RS-04-069

LaSalle County Station, Units 1 and 2
Facility Operating License Nos. NPF-11 and NPF-18
NRC Docket Nos. 50-373 and 50-374

Subject: License Amendment Request
Activation of the Trip Outputs of the Oscillation Power Range Monitor System

Figure 3.4.1-1, "Power versus Flow," and associated references to the figure from the LCO, Actions, and SRs are deleted.

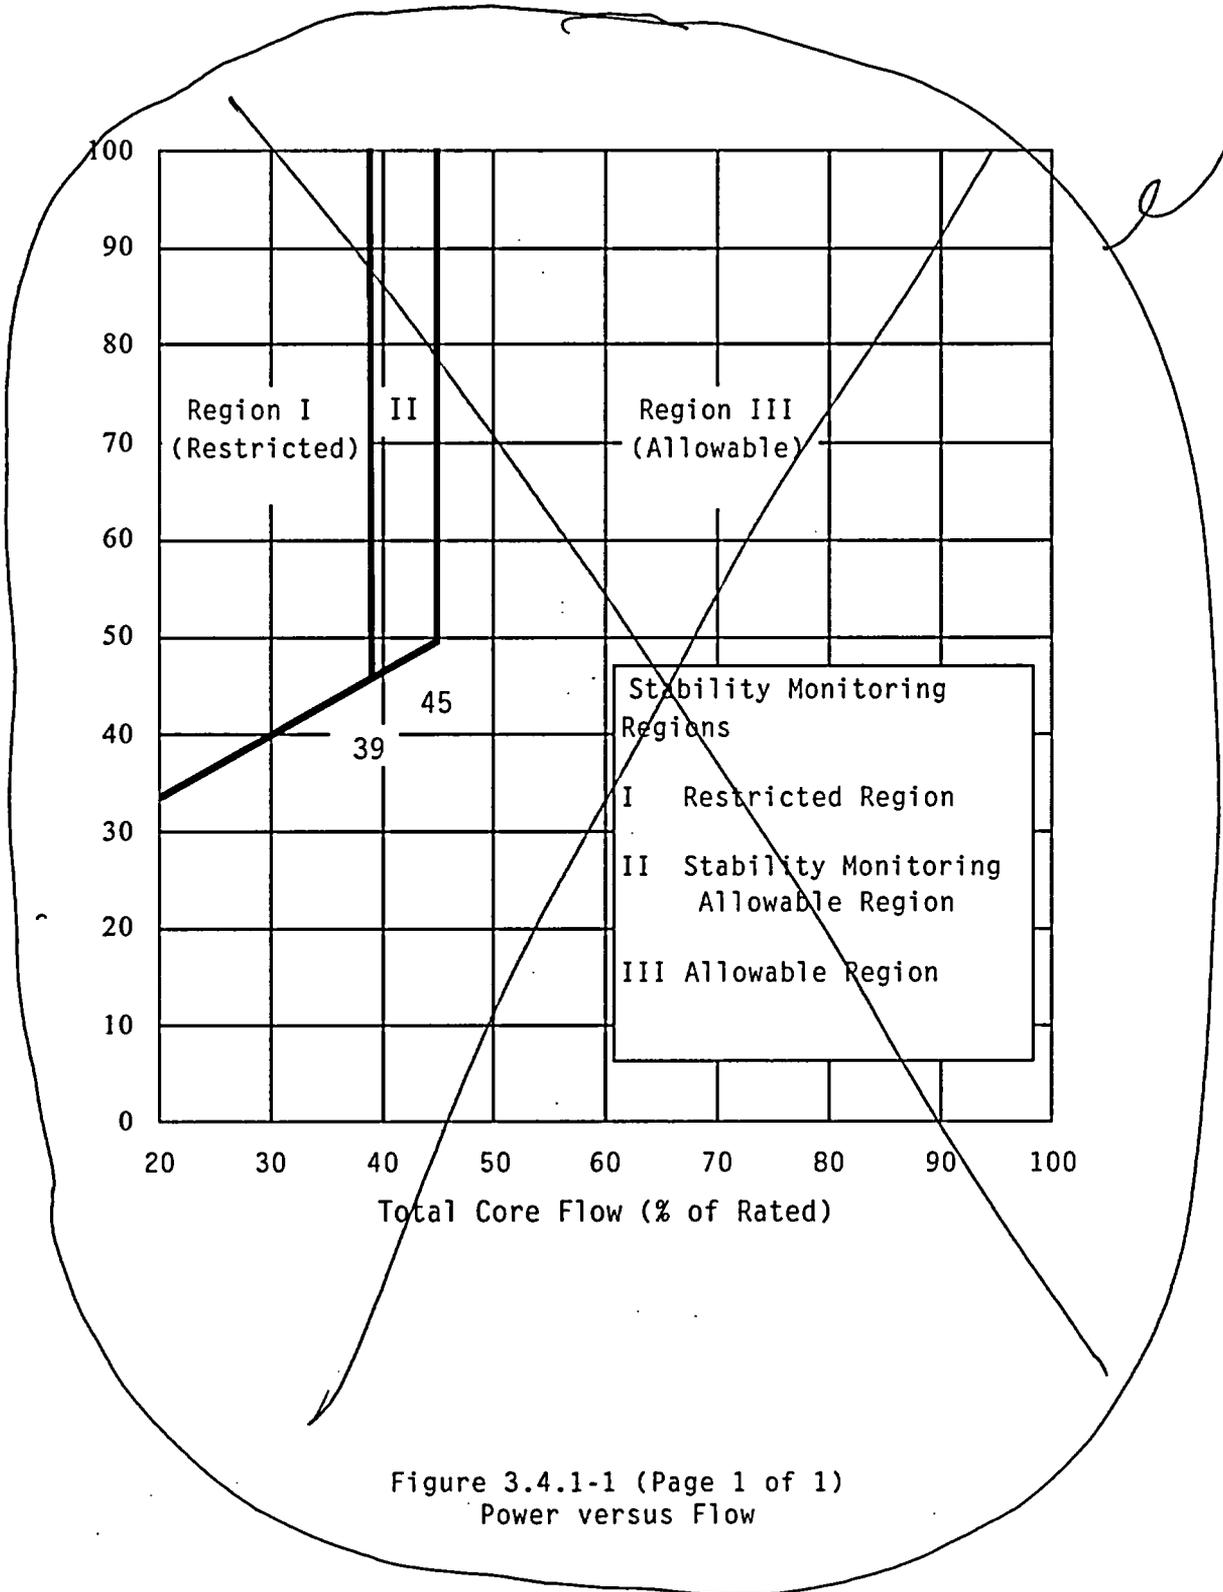
LCO 3.4.1 Two recirculation loops with matched flows shall be in operation, ~~within Region III of Figure 3.4.1-1~~

One recirculation loop shall be in operation ~~within Region III of Figure 3.4.1-1~~ with the following limits applied when the associated LCO is applicable:

The incorporation of the OPRM instrumentation into the TS will allow the deletion of the Power versus Flow TS Figure and associated references. The OPRM Instrumentation will provide at least the same level of assurance that the MCPR safety limit will not be violated for anticipated oscillations as that provided by the current stability requirements in the LCS TS.
